Metro Outer Joint Development Assessment Panel Agenda

Meeting Date and Time: Thursday, 9 September 2021; 9:30am
Meeting Number: MOJDAP/122
Meeting Venue: Via Zoom

Development Description: Redevelopment of Existing Service Station and Fast Food Outlet Addition
Applicant: Planning Solutions
Owner: Bass Management Pty Ltd
Responsible Authority: City of Joondalup
DAP File No: DAP/21/02012

Development Description: Modifications to Service Station and Showrooms (Pylon Sign)
Proposed Amendments: Modifications to an existing Service Station Pylon Sign
Applicant: Planning Solutions
Owner: Accord Perth Eden Beach Pty Ltd
Responsible Authority: City of Wanneroo
DAP File No: DAP/19/01700

PROPOSED SITE PLAN WITH NEIGHBOURING DEVELOPMENT
SCALE: 1:200

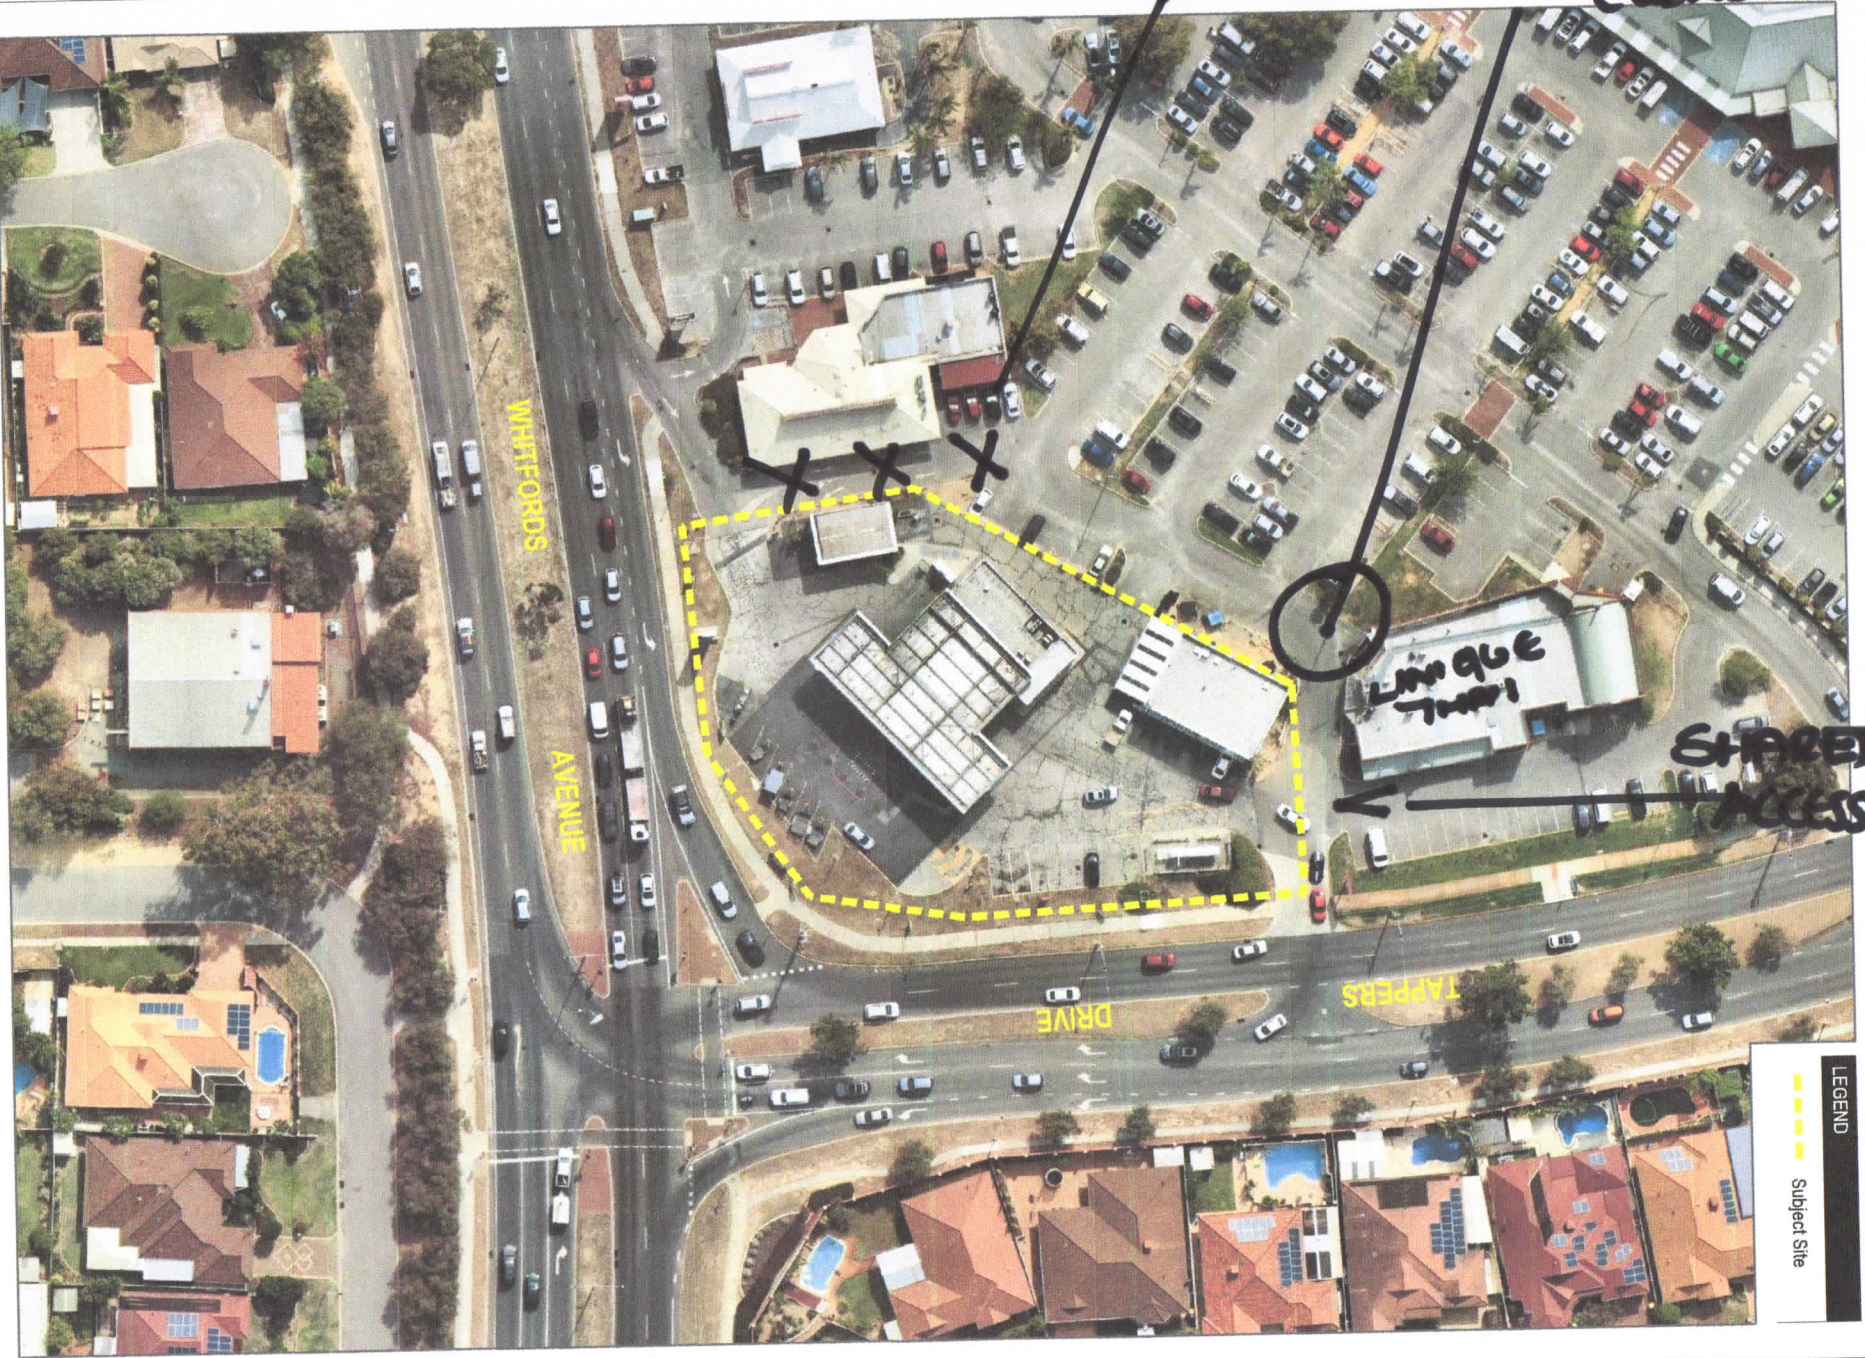
To confirm I ask the panel to direct the developer to re-design the plans so

- Appropriate parking provision are provided as per the LPP, that provide the 30 general universal parking spaces at any given time
- Removal of staff car parking adjacent to the access way
- Consideration to the appropriate usage of the dual accessway for all parties, to provide a fair and equitable liability of costs
- A design that provides an additional EXIT point
- A design that ensures patron to LOT 1 will not utilise the parking in Strata LOT 8 under any circumstance
- A design that ensures LOT 8 does not experience thru traffic to exit via the northern access on to Trappers Drive

TO REMOVE
LOT9 REDVELOPED

BLIND
CORNER

Photo 2: Pinjar Road southbound – 40m from start of left turn lane into Porrecta Link

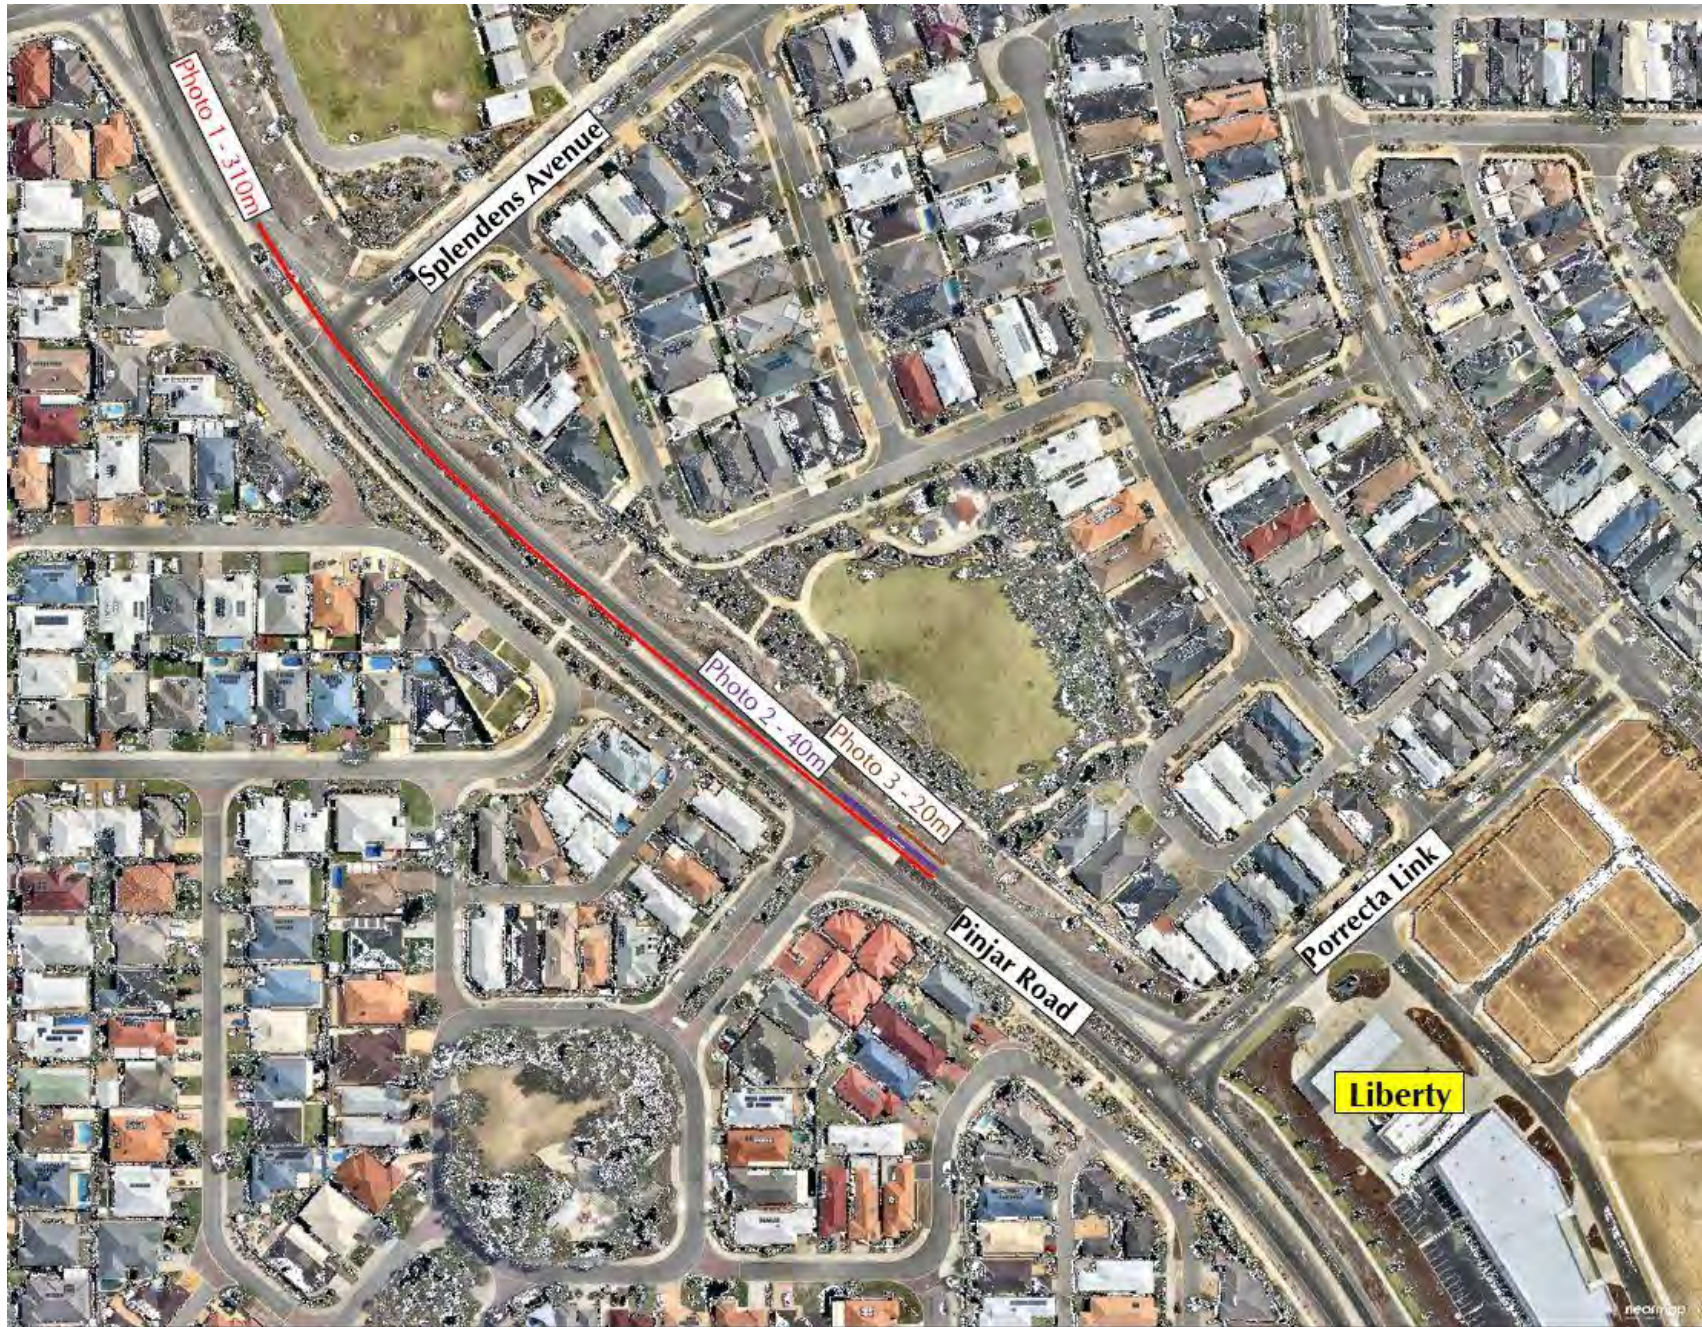
Recommendation 2.5.1 Improve recognition of the service station for drivers on Pinjar Road by relocating the Service Station sign and/ or removing trees that block sight lines to this sign. IMPORTANT MEDIUM	Agree & Disagree	Existing trees to remain. Any removal of vegetation will be considered by the City on a case-by-case basis and may be subject to offsets and/or cash payment based on City adopted Street Tree Policy and tree valuation methodology.	City supports the relocation of the signage subject to relevant planning approvals and sight line considerations.
